NOTICE OF DECISION

1838 Franklin Street / Franklin Offices Site Plan

Land Use Application Nos.:	SPR-21-002 (Site Plan Review – Type 2) SEP-21-001 (SEPA)
Applicant and Owner:	Jeff Rauth 500 Grade Street Kelso, Washington, 98626
Site Location:	“1838” Franklin Street Woodland, WA 98674
Parcel & Size:	50728, 4.08 Acres
Zoning Designation:	Highway Commercial (C-2)
Date Application Received:	March 18 th , 2021
Notice of Application & Likely DNS issued:	Revised: May 16 th , 2022 Original: April 15 th , 2022 [See: case # SEP-21-001]
Comment Period & SEPA Appeal Period Ended:	Revised: May 30 th , 2022 Original: April 29 th , 2022
Notice of Decision Issued:	June 1 st , 2022
DRC Decision:	Approve with Conditions

SITE PLAN

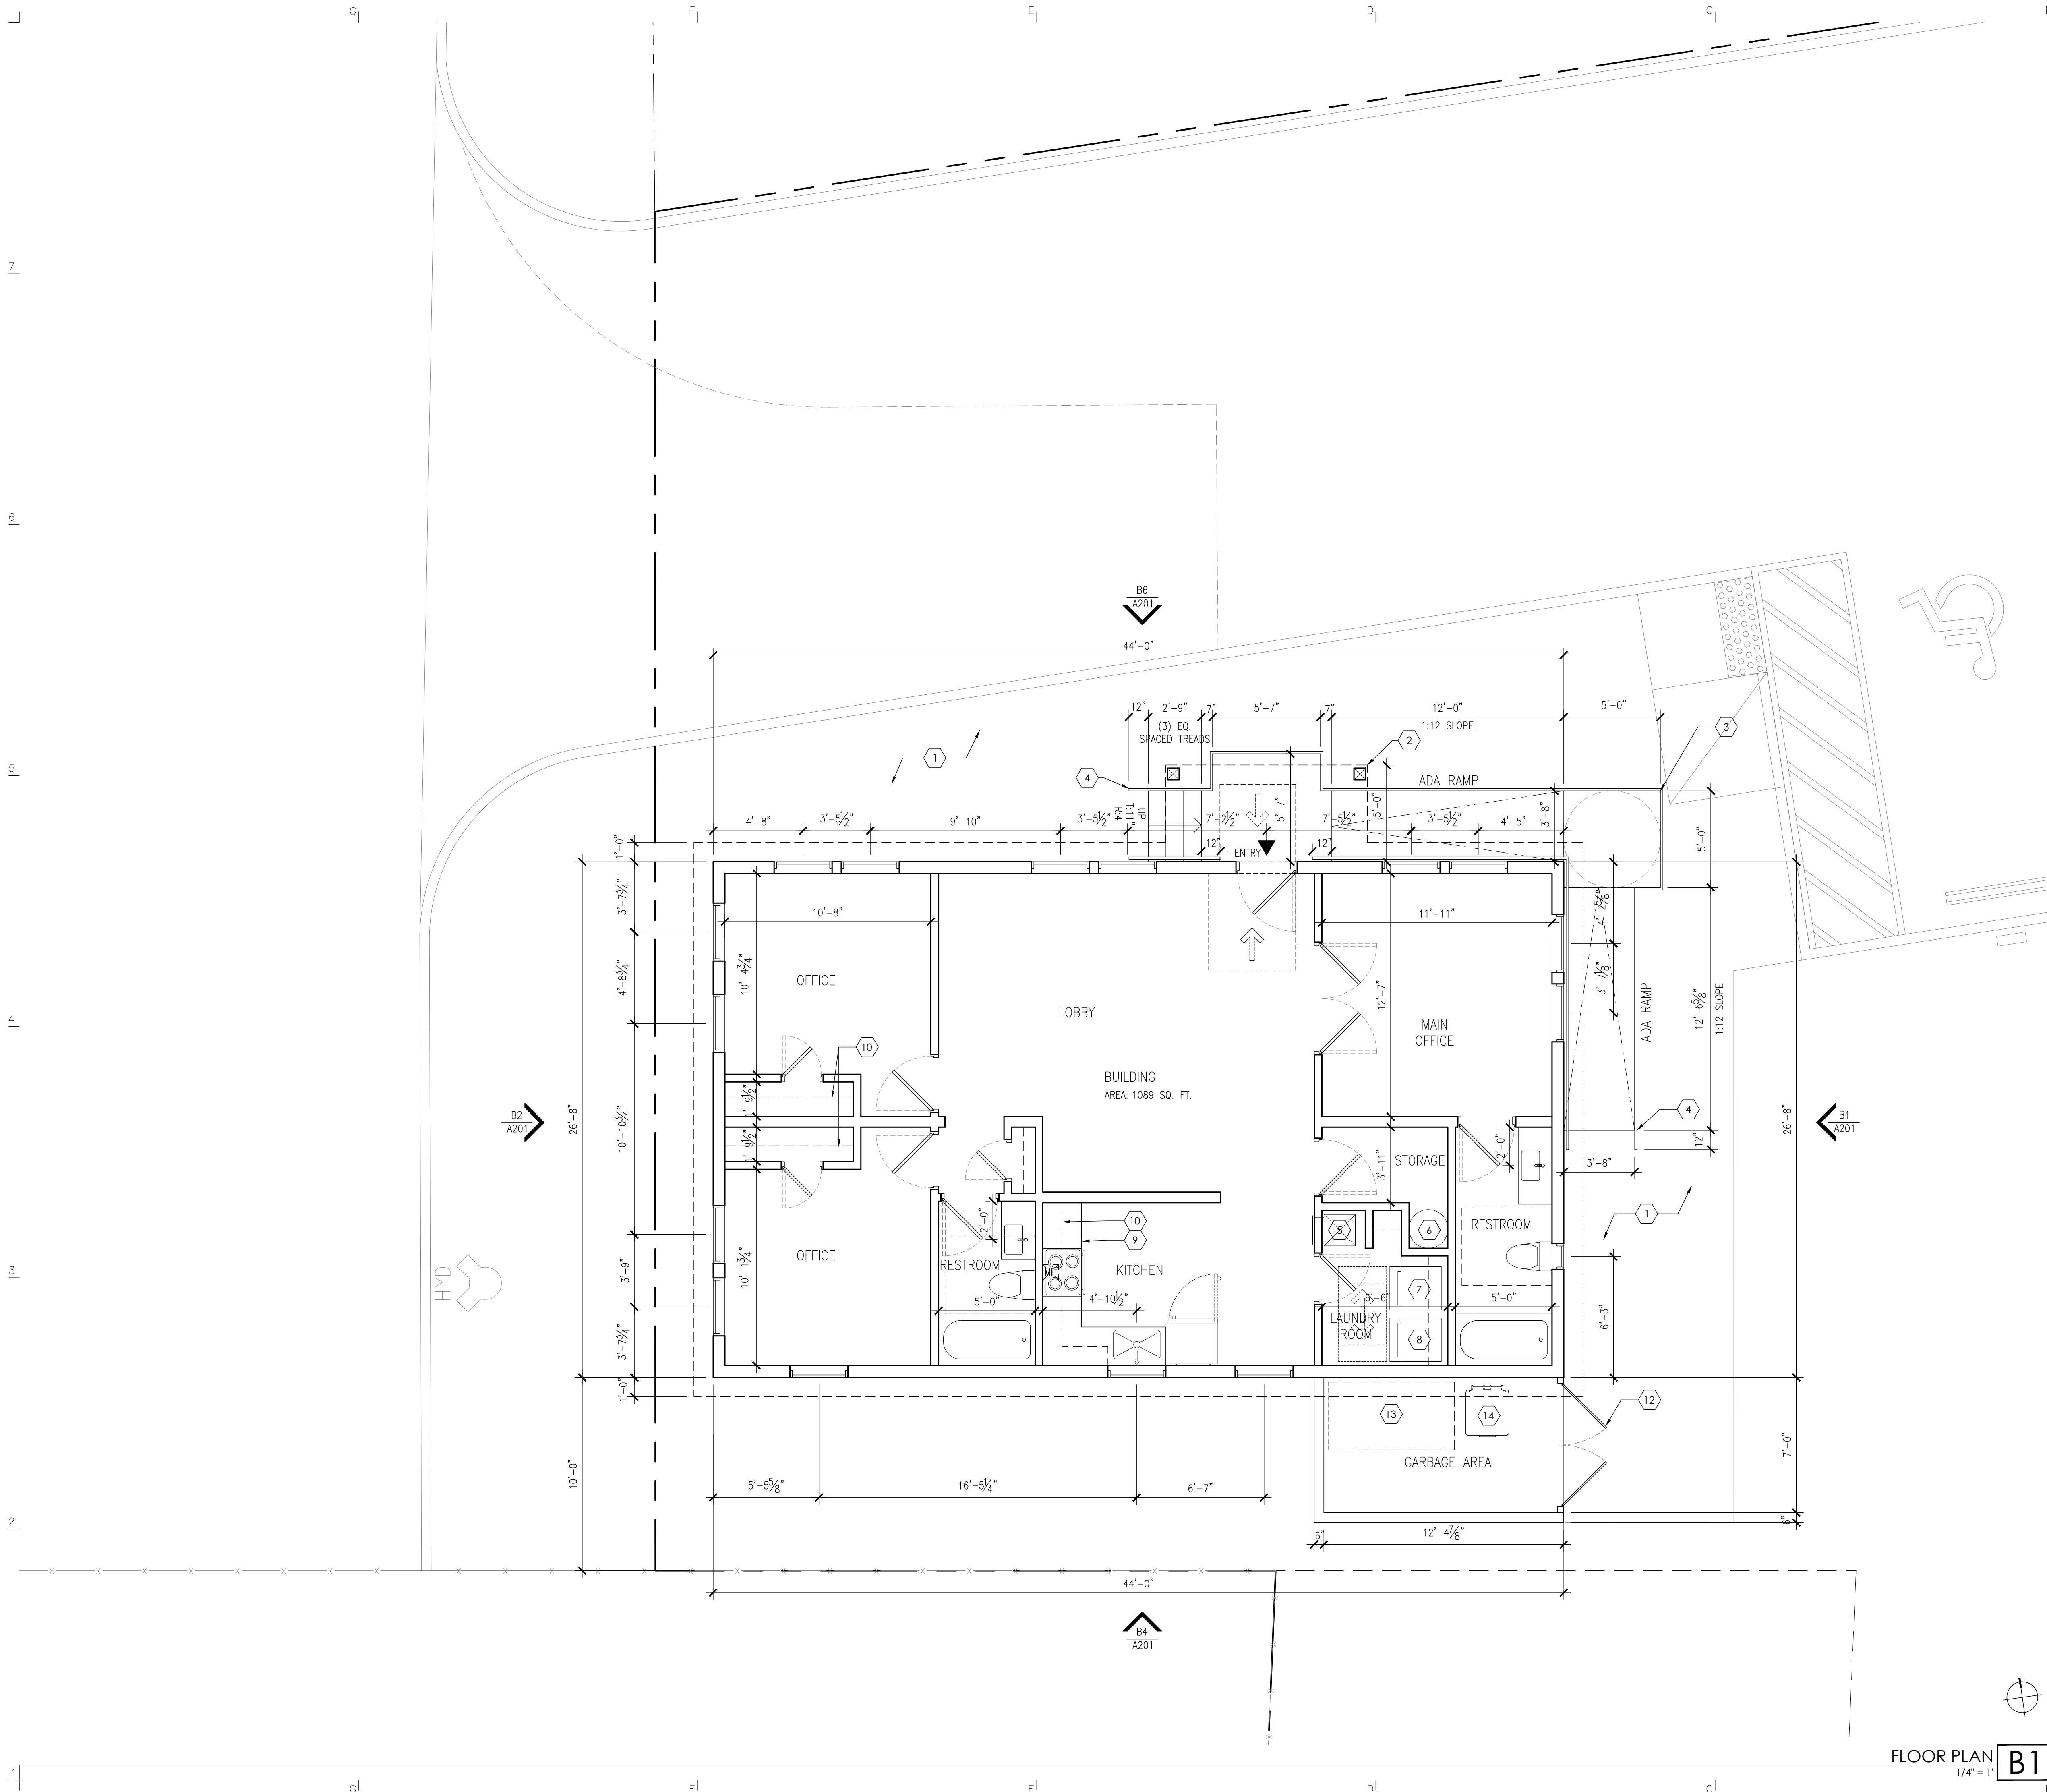
Finding 5B: Preliminary plans provided shows new frontage improvements including a 26.3-foot-wide driveway, a type A-1 concrete curb and gutter, and a 6-foot detached sidewalk. These are acceptable in scope, however the City updated our transportation standards in February 2022, and our standard sidewalk requires a width of 6 feet. (*See condition 3*)

Finding 6B: No street trees are indicated on the preliminary landscaping plan. In order to comply with WMC 12.28, a condition has been added that the applicant shall provide one street tree along their frontage on Franklin Loop. (*See Condition 4*)

Finding 26: Plans submitted for review show an entrance facing to the north towards Belmont Loop with large windows facing West towards Franklin Street frontage. However, the building proposed, as well as provided landscaping, is prominent with large windows fronting Franklin Street, as well as clear visibility between the entrance and the street over the driveway.

Finding 41: Per WMC 17.36.130 (N) (1), a landscape buffer strip of at least five feet is required along the entirety of the public street frontage excluding ingress and egress points, and areas where structures and pedestrian-oriented space is located. No landscape buffer is indicated on provided plans, however public street frontage meets the requirements to be considered exempt from this requirement, with the driveway and building taking up most of the frontage.

Finding 44: Provided Site Plan indicates that the site will have a total of four parking spaces, including one handicapped space, and there is one proposed tree in the parking lot area. Tree is identified on preliminary plan as being an Acer Ginnala "Flame Amur Maple" measured at 1.5" Caliper within the provided project narrative. Per Woodland's general landscaping requirements within the Highway Commercial district, this is an appropriate planting.

Finding 45: Screening of trash and service areas: Trash area on site is identified as being fully screened by a pre-fabricated seven foot by 12 foot 4 inch enclosure, with a height of 6 foot and 6 inches per provided plans. This fulfills requirements outlined in WMC 17.36.130 (P), which states that all mechanical and communication equipment, including loading docks, garbage receptacles, and recycling containers shall be fully obscured from public view by either a decorative wall (i.e., masonry, wood, or similar quality material), evergreen hedge, and/or opaque fence shall be used for screening. The proposed enclosure meets these expectations. (*See Condition 17*)

2. All impact fees are charged with building permit issuance. All provided calculations are estimated and subject to change.
3. Half street improvements will be required to be designed and installed consistent with city engineering standards. Construction standards may be found: <https://www.ci.woodland.wa.us/publicworks/page/construction-standards>.

4. Final landscaping plan provided for review must identify at least one proposed street tree to be planted within the Right of Way (RoW) alongside the sidewalk.

FLOOR PLAN

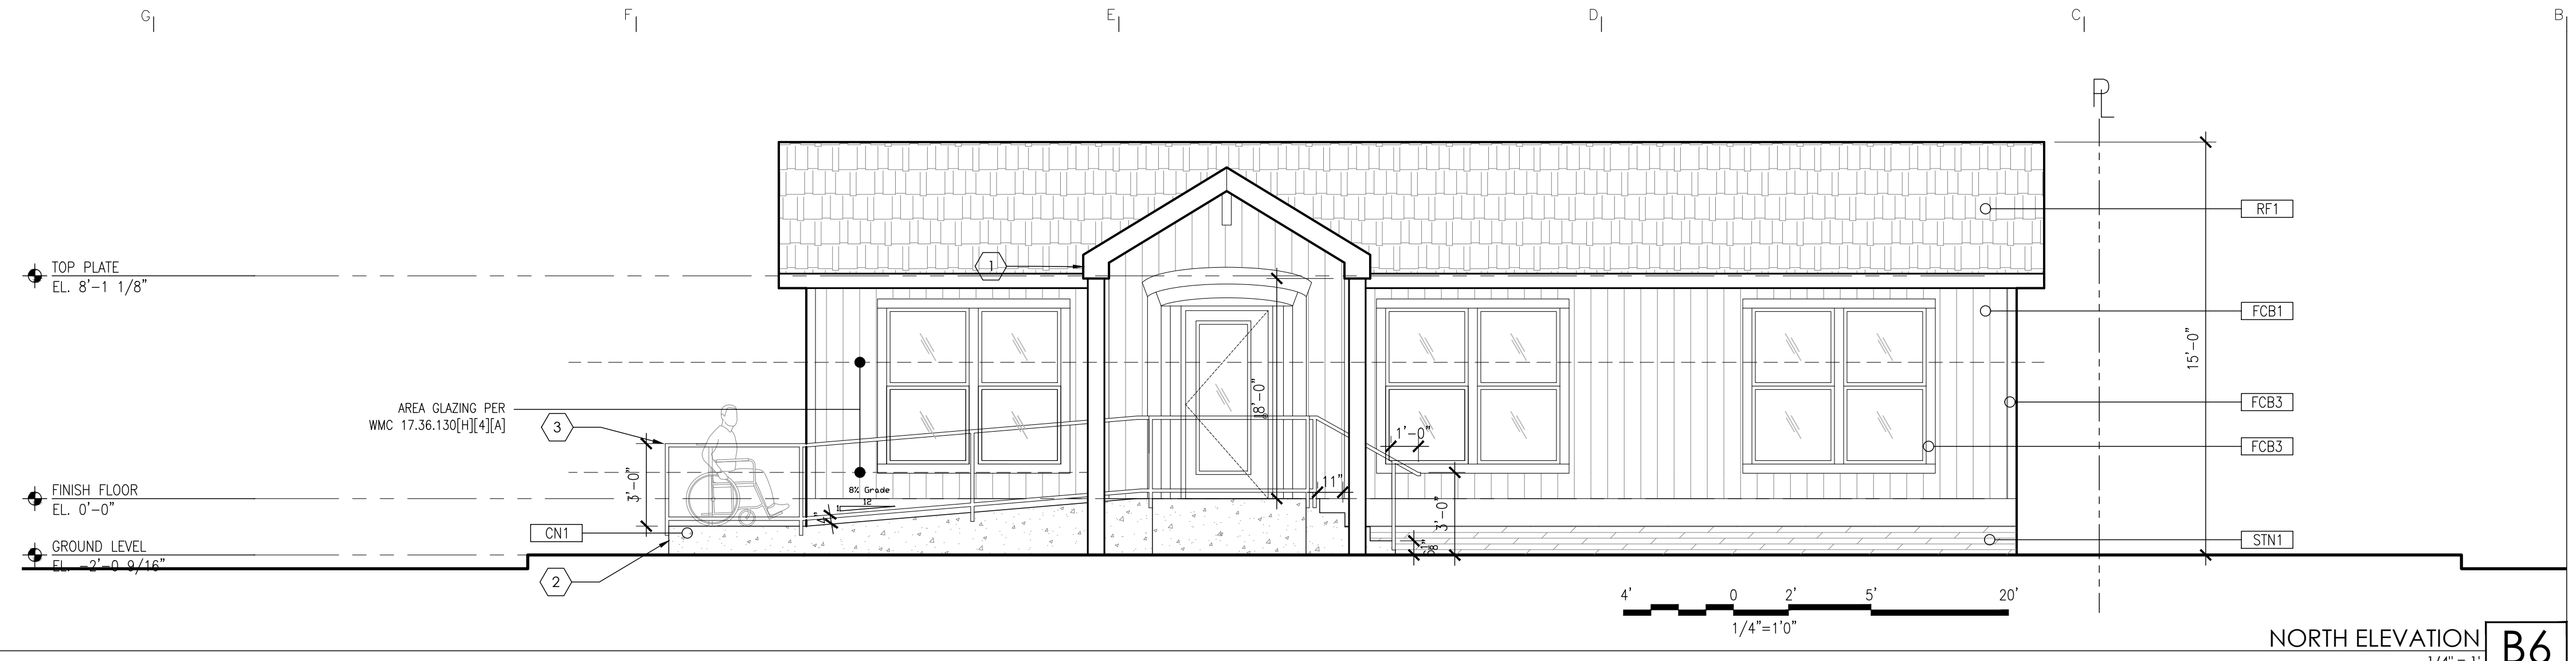
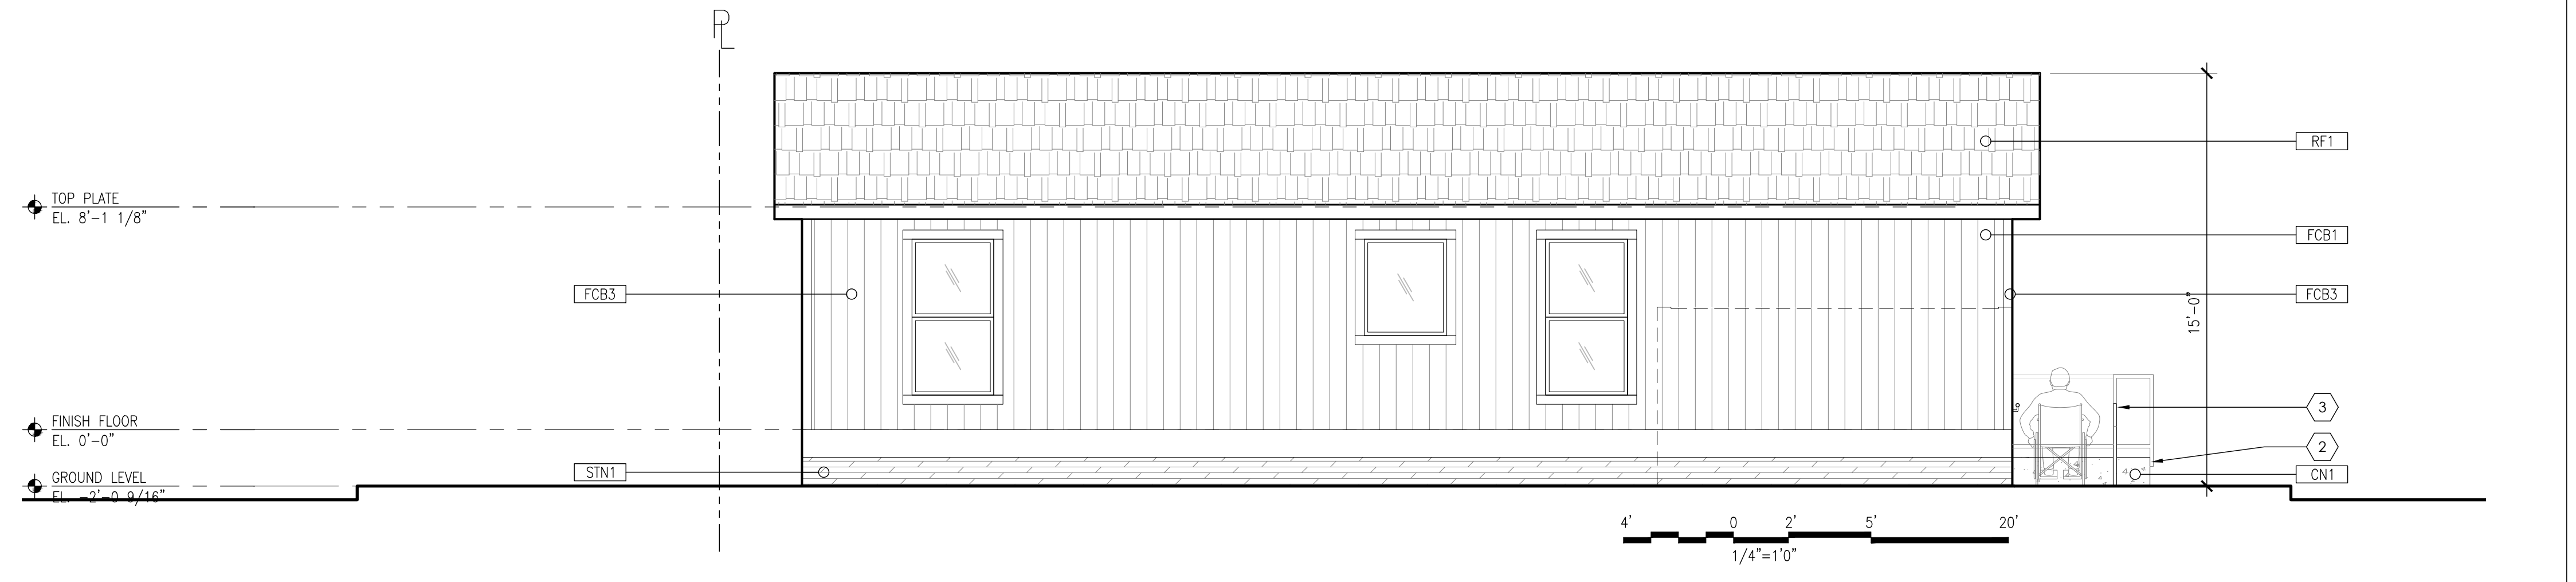
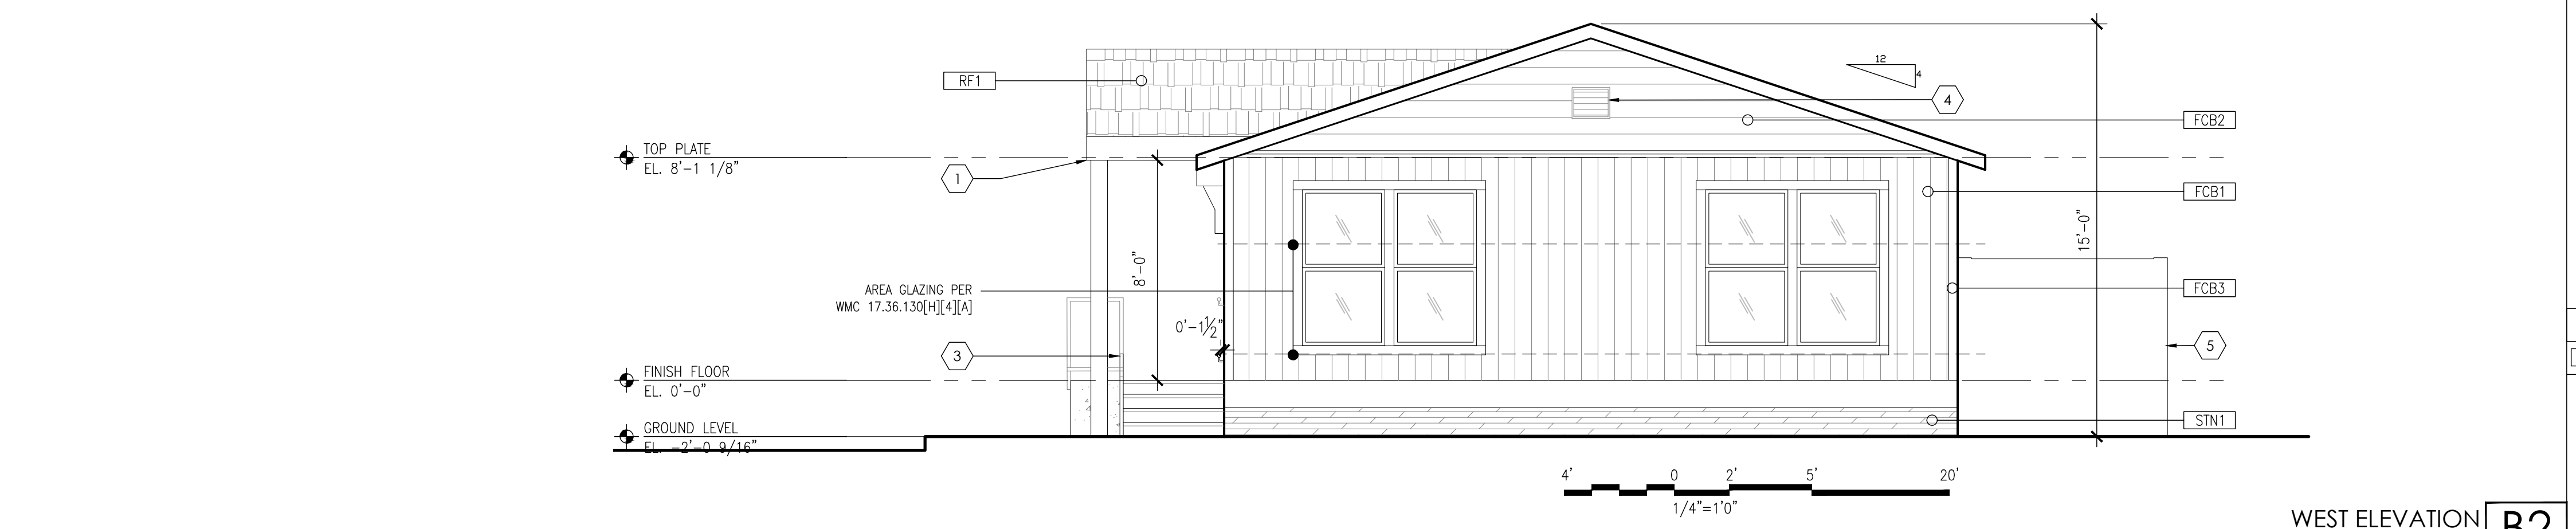
Finding 23: Proposed structure does not comply with WMC 17.36.080. A condition has been added that the final proposed structure must meet the minimum building height standard as measured from grade to the average height of the highest gable. (*See Condition 11*)

Finding 30: Per WMC 17.36.130 (G) (2), Canopies and/or awnings shall be provided along a minimum of sixty percent of any facades that give access to the building. Minimum depth of any sidewalk canopy and/or awning shall be five feet and must give between eight and twelve feet of clearance from the sidewalk and the underside of any awning. A condition of approval has been added that an awning shall be provided that covers 60% of entry façade. (*See Condition 12*)

Finding 33: The Western and Northern facades are visible from the street. The northern facade has three identified large glass windows, as well as a glass door, which suggests compliance with the thirty percent transparency requirements while the western façade has identified two similar windows that suggest compliance with the thirty percent transparency requirements per WMC 17.36.130(H)(4)(a). A condition of approval has been added that the applicant shall provide dimensions and appropriate details of proposed windows to confirm compliance with WMC 17.36.130(H)(4)(a). (*See Condition 13*)

11. Proposed building height must meet the minimum height of 15 feet within the Highway Commercial district, as measured from grade to the average height of the highest gable. Such revisions shall be submitted alongside civil plans for review.

12. A canopy and/or awning covering a minimum of 60% of any façade that provides an entrance is required, and dimensions should be shown on all relevant plans.

13. Applicant shall provide relevant detail and dimensions of all proposed windows.
14. Any curb cuts, road improvements, and/or other work to be done in the Right-of-Way will require an approved Right-of-Way permit.
